SUNDRY NOTICES AND REPORTS ON WELLS

Filaree '18' Federal #1

9. API Well No.
3001531707

- ☒ Change of Plans
☐ New Construction
☐ Non-Routine Fracturing
☐ Water Shut-Off
☐ Conversion to Injection
☐ Dispose Water

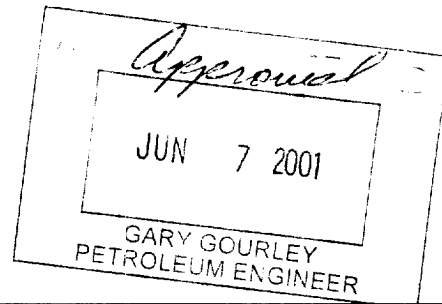
Also Concho Resources Inc. requests approval to change the 9-5/8" casing design on the APD for this well as follows:

Drill 12-1/4" hole to 4900'. Set 900' of 40# S80 STC & 4000' of 40# K55 STC csg. Cmt w/ 1200 sx C lite & tail w/ 200 sx C + 1% CaCl₂. Circulate cmt to surface.
